Item ID: D3016-041 Accept *N900040100* Setup Start *NS1*
 Revision ID: Stop *NS2*
 Item Name: Seat Frame Assembly
 Start Date: 9/17/12 Start Qty: 1.00 *1* Cust Item ID:
 Required Date: 10/12/12 Req'd Qty: 1.00 *1* Customer:
 Reference:

DESIGN CP	DRAWN BY CP	DART AEROSPACE LTD HAWKESBURY, ONTARIO, CANADA	
CHECKED #	APPROVED #	DRAWING NO. D3016	REV. A SHEET 1 OF 3
DATE 01.05.18		TITLE SEAT FRAME ASSEMBLY	SCALE NTS
A	01.05.18	NEW ISSUE

DRAWING NO. D3016	TITLE SEAT FRAME ASSEMBLY	REV. A	DART AEROSPACE LTD ENGINEERING ORDER	D.E.O. NO. D3016-A-1	SHEET NO. SHEET 1 OF 1	SCALE NTS
DRAWN 1	CHECKED UP	MFG. APPR. R	APPROVED MAP	DE APPR. H		
DATE 10.01.29	DATE 10.01.29	DATE 10.01.29	DATE 10.01.29	DATE 10.01.29

DETAIL D3016-11 SADDLE (SHEET 3): Ø0.257 TYP 3 PL WAS Ø0.191 (TYP 3 PLACES) AS SHOWN:

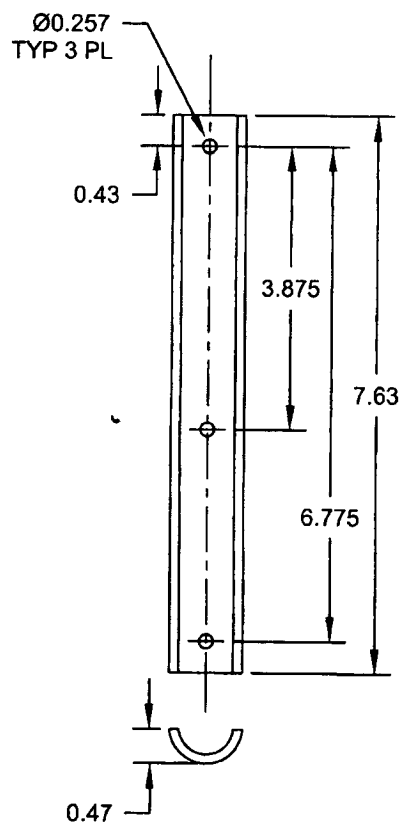
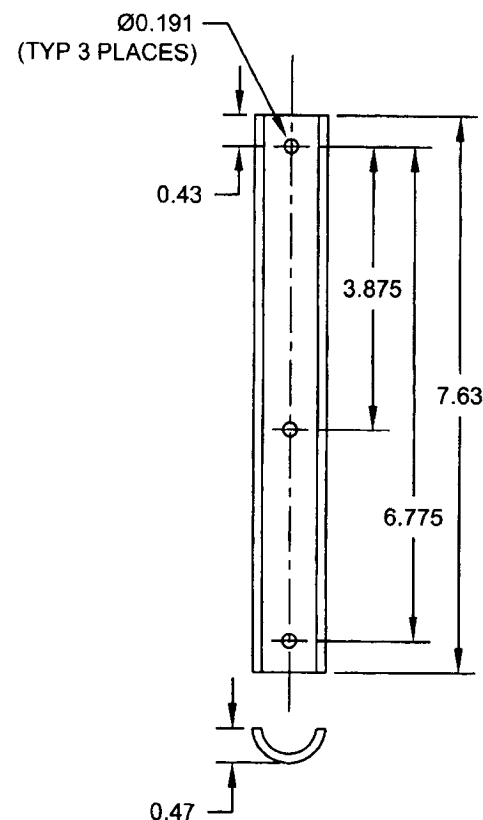
TO REVISE D3016-11 SADDLE'S HOLE SIZES
